CCO #42 Review Comments
By
Sandy Michelotti & Michael Travis
March 21, 2008

SAS SUPERSTRUCTURE ROADWAY WESTBOUND
LIGHTING AND ELECTRICAL SYSTEMS

480 V OVERHEAD SIGN

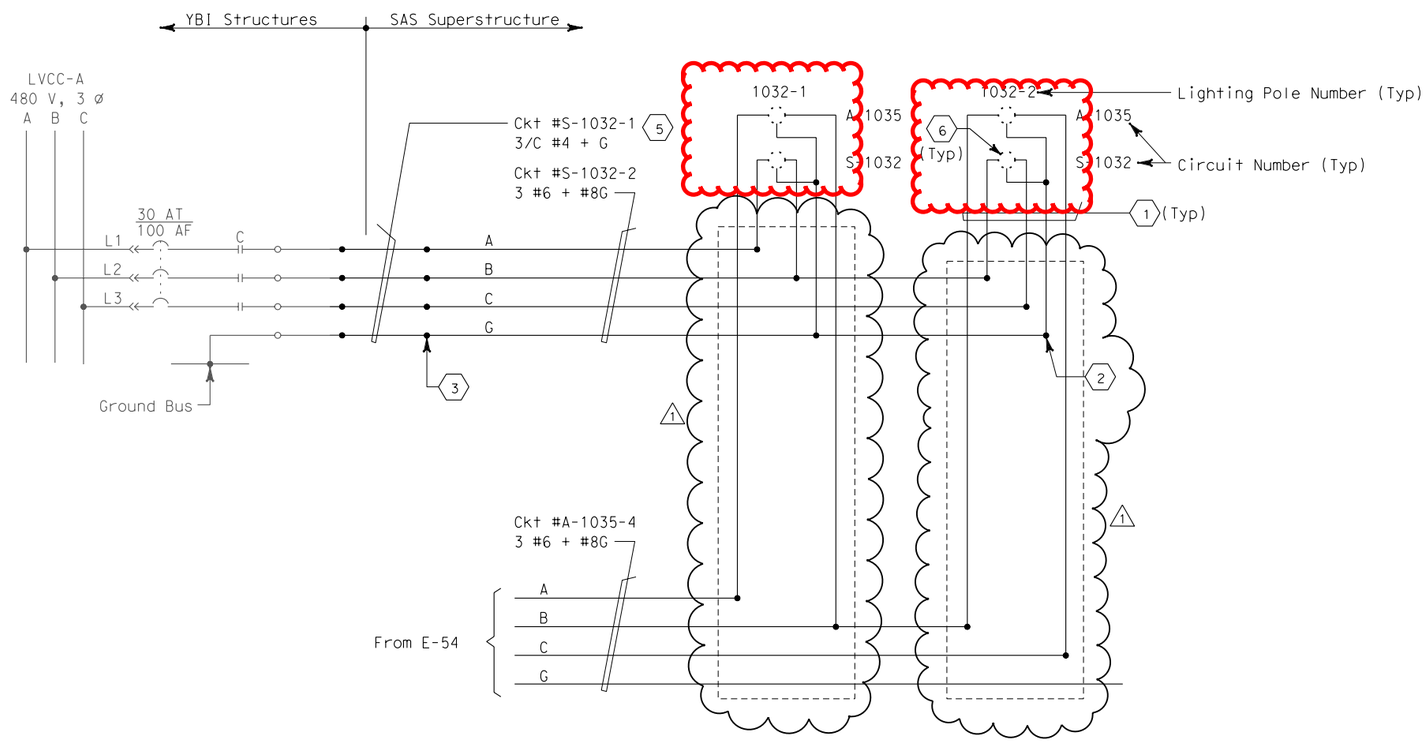
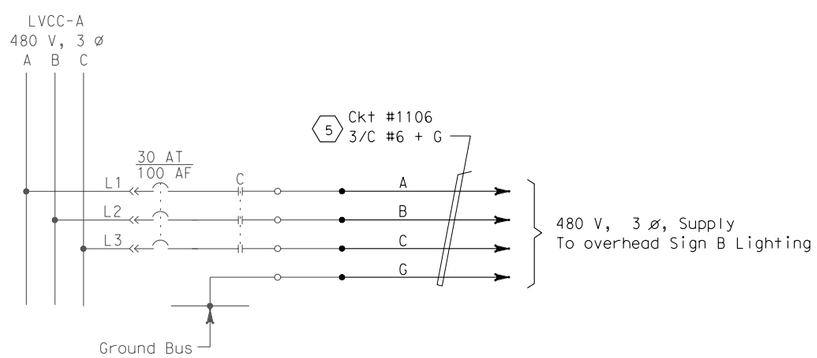
1. The removal of the light poles are not in this CCO.
   Remove all references to state furnished poles and detailing showing the poles are by others.
   The removal of the poles will take place in CCO #43.

SAS SUPERSTRUCTURE - CONDUIT PLAN

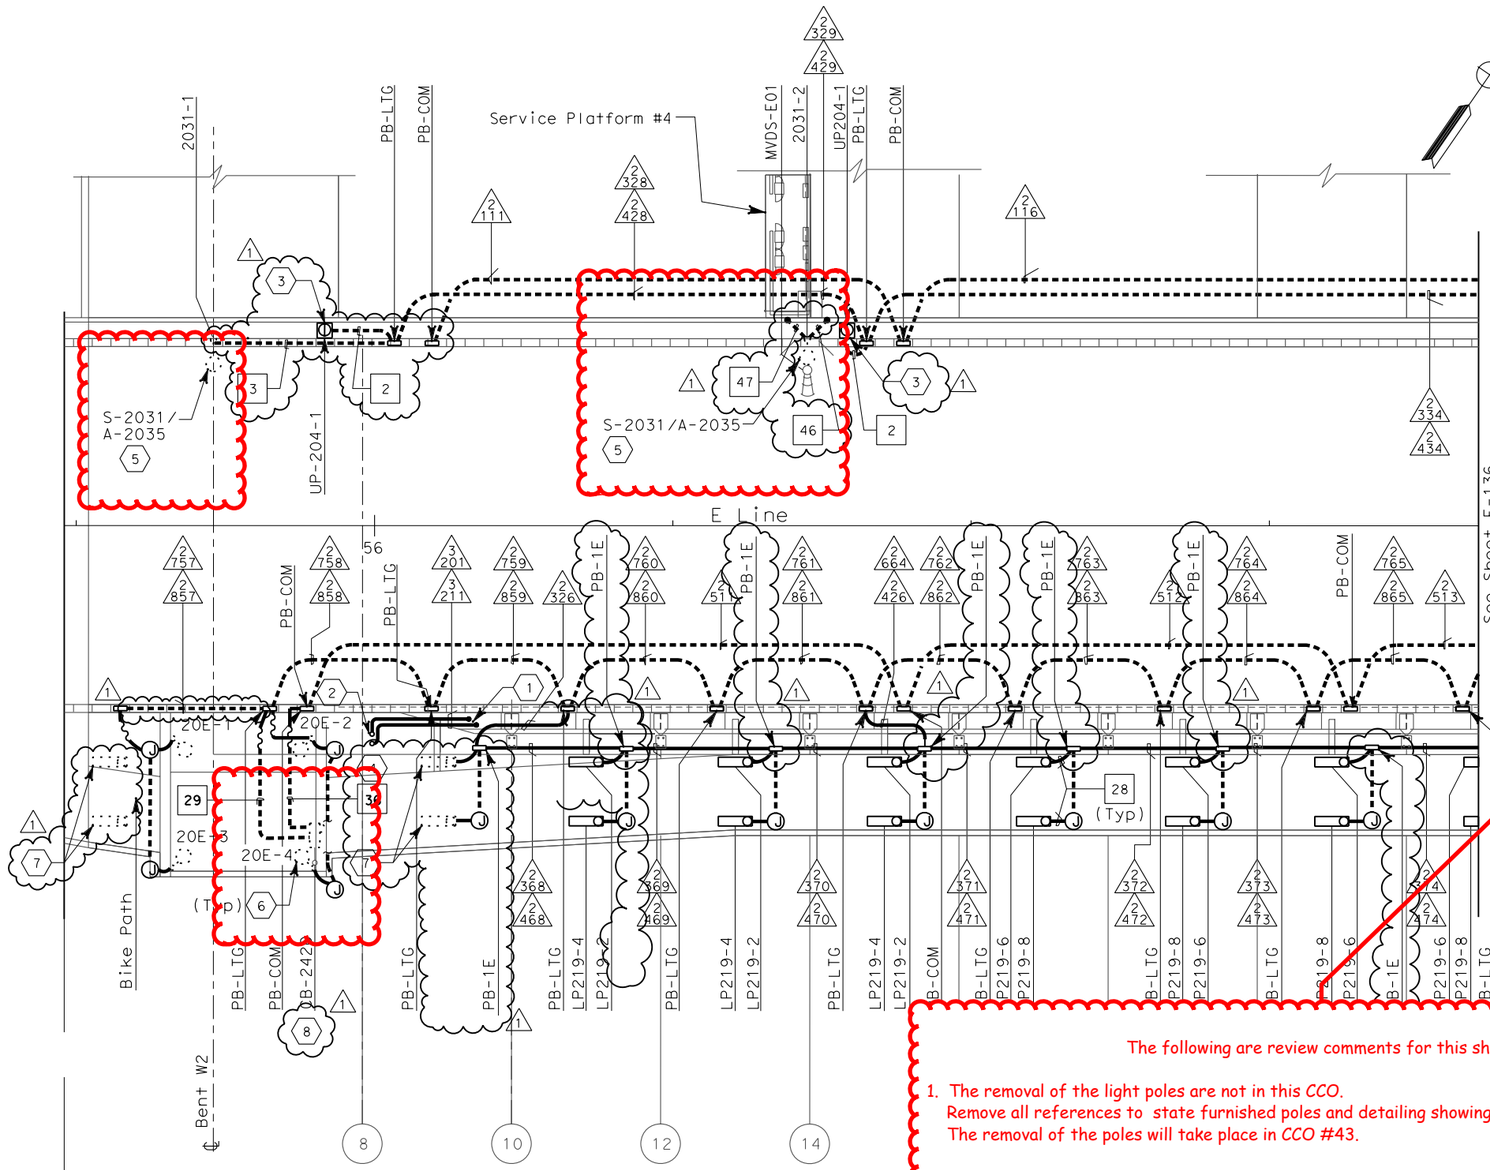
1. The removal of the light poles are not in this CCO.
   Remove all references to state furnished poles and detailing showing the poles are by others.
   The removal of the poles will take place in CCO #43.

SAS SUPERSTRUCTURE - CONDUIT PLAN

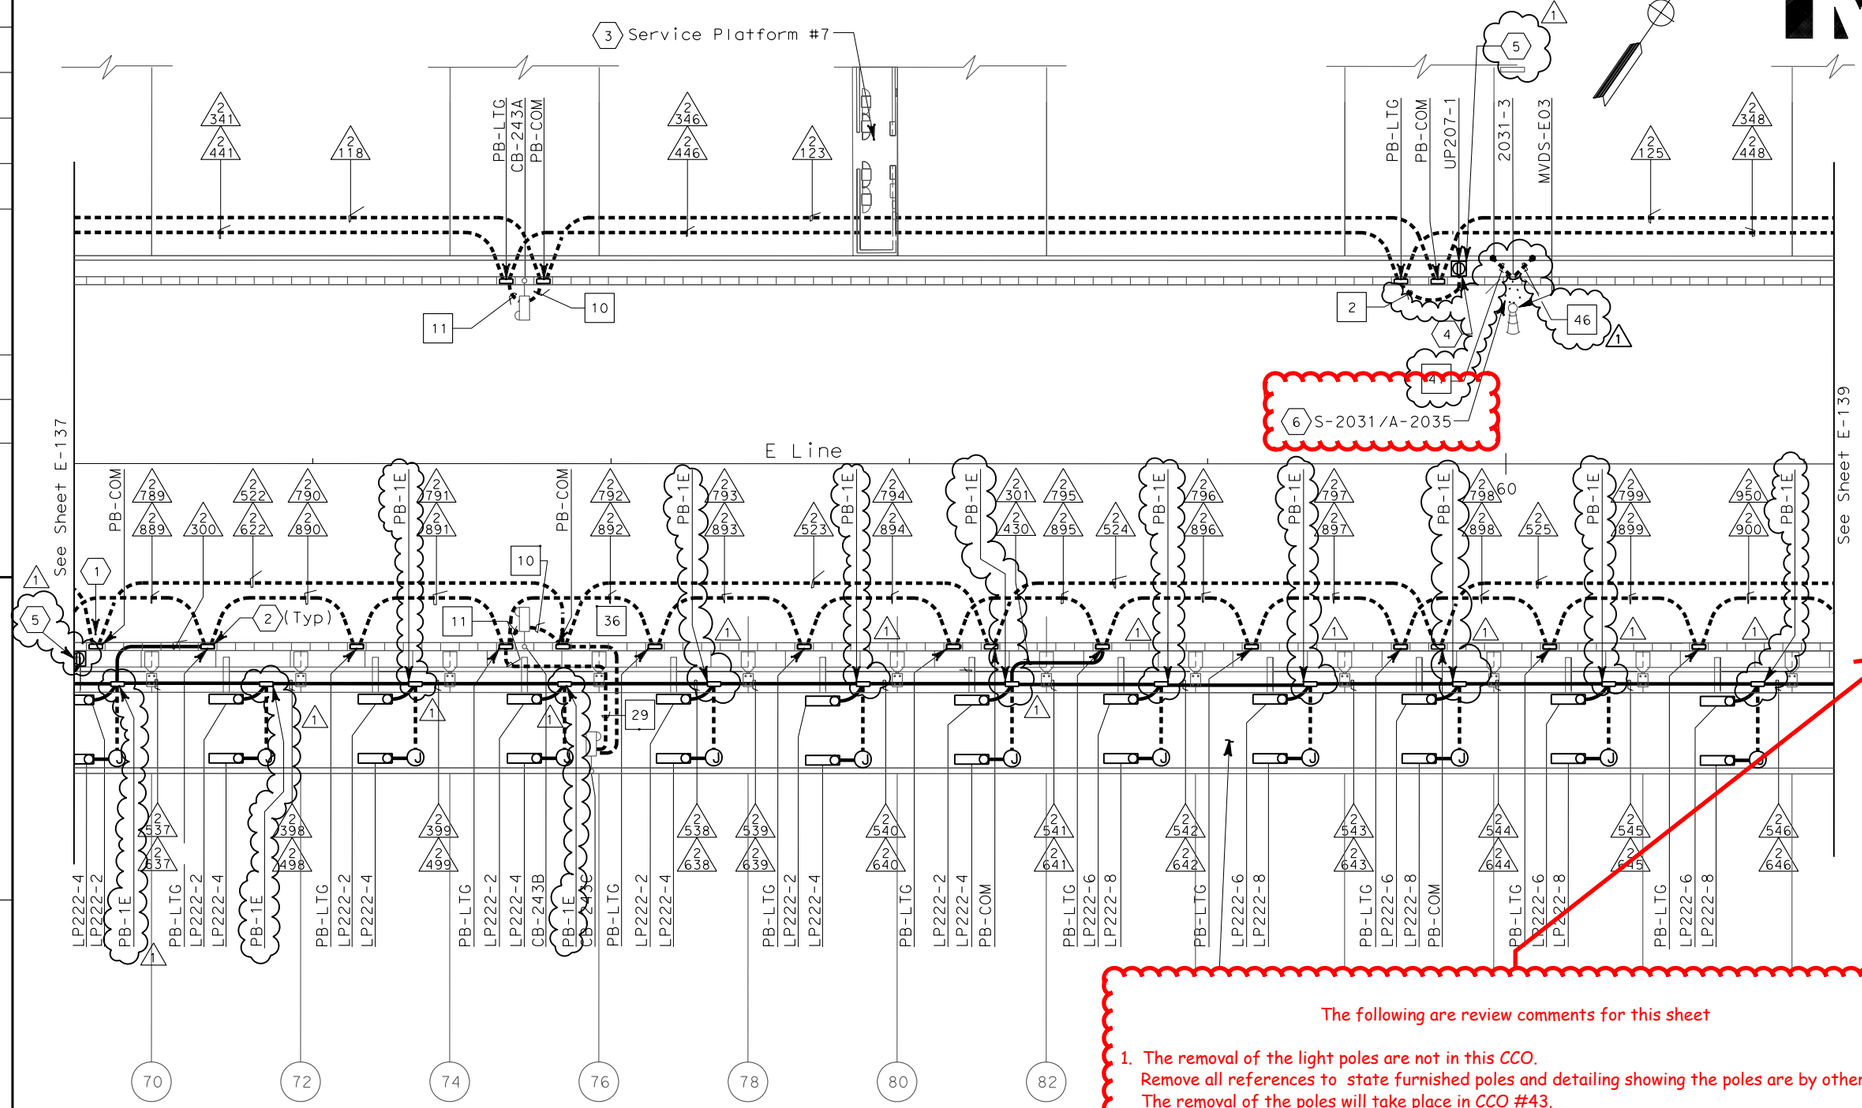
1. The removal of the light poles are not in this CCO.
   Remove all references to state furnished poles and detailing showing the poles are by others.
   The removal of the poles will take place in CCO #43.

SAS SUPERSTRUCTURE - CONDUIT PLAN

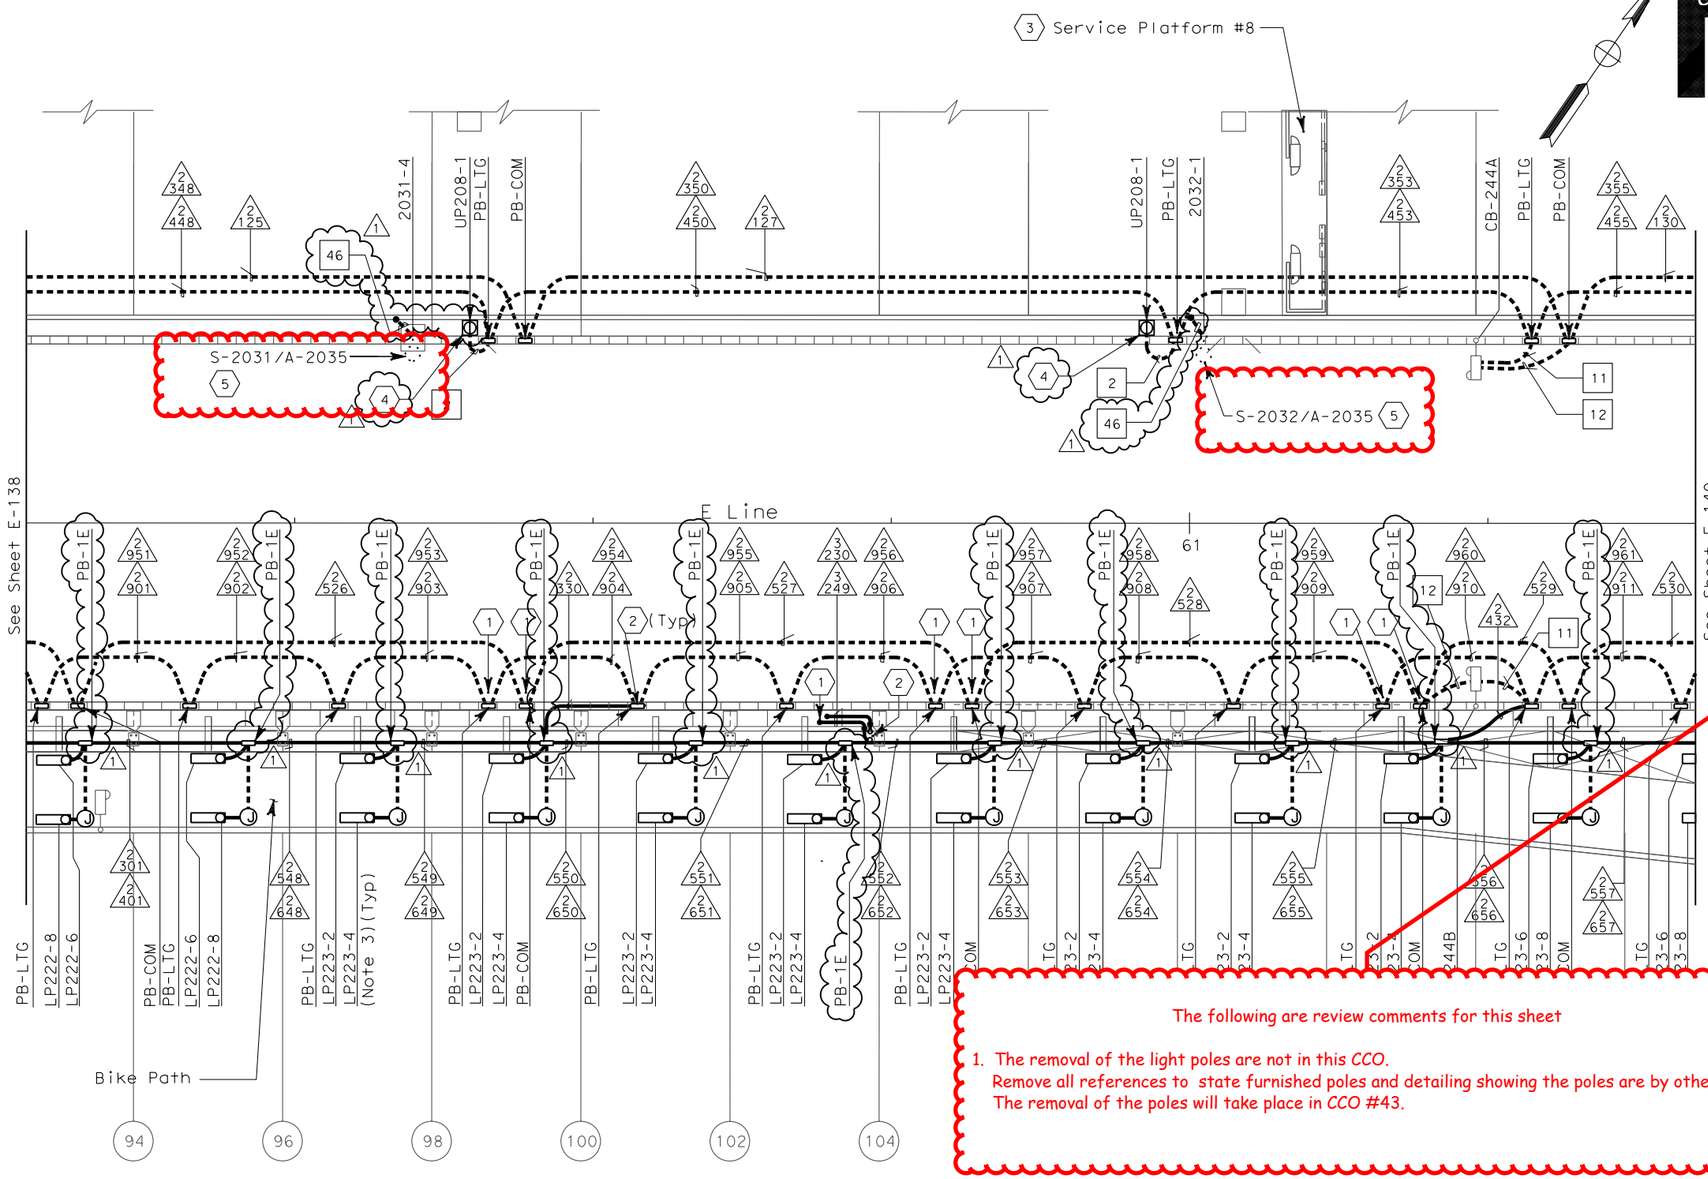
1. The removal of the light poles are not in this CCO.
Remove all references to state furnished poles and detailing showing the poles are by others.
The removal of the poles will take place in CCO #43.

SAS SUPERSTRUCTURE - CONDUIT PLAN

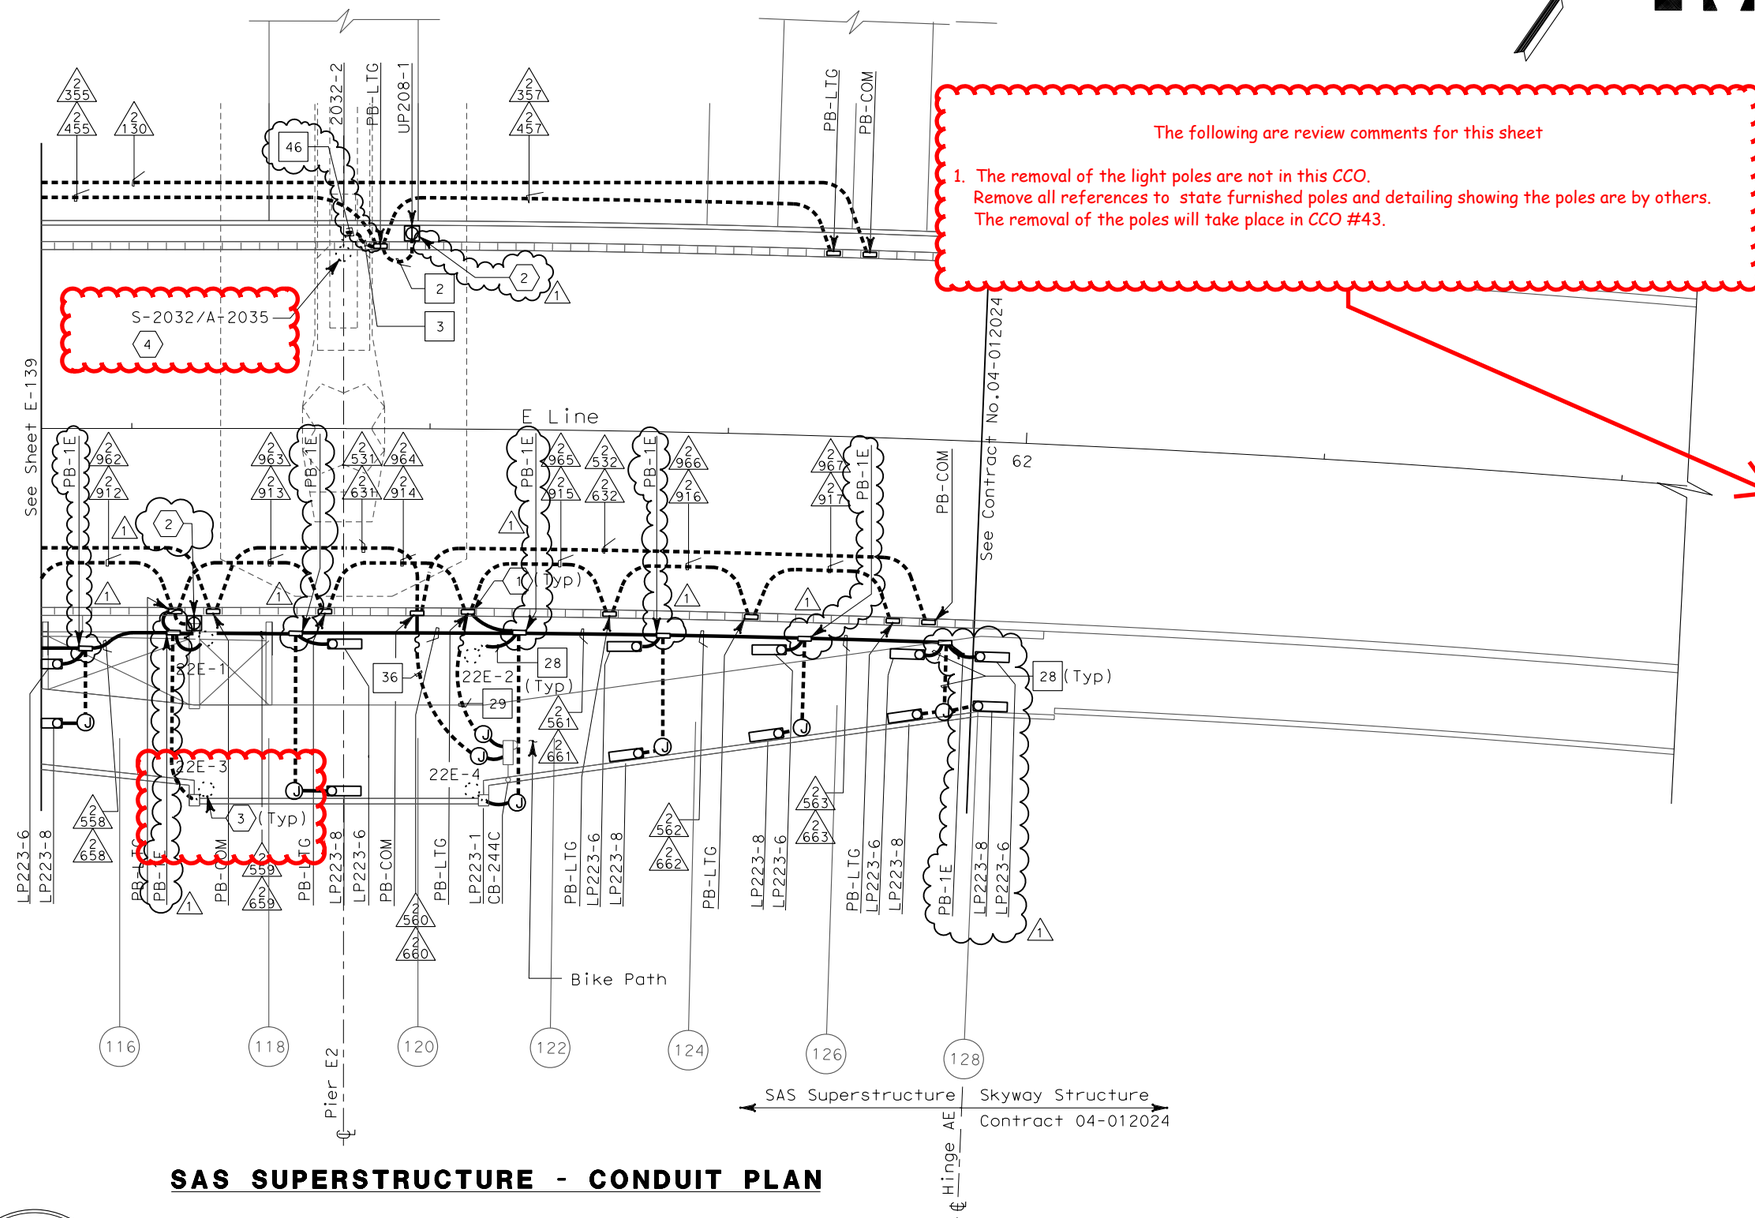
1. The removal of the light poles are not in this CCO.
   Remove all references to state furnished poles and detailing showing the poles are by others.
   The removal of the poles will take place in CCO #43.
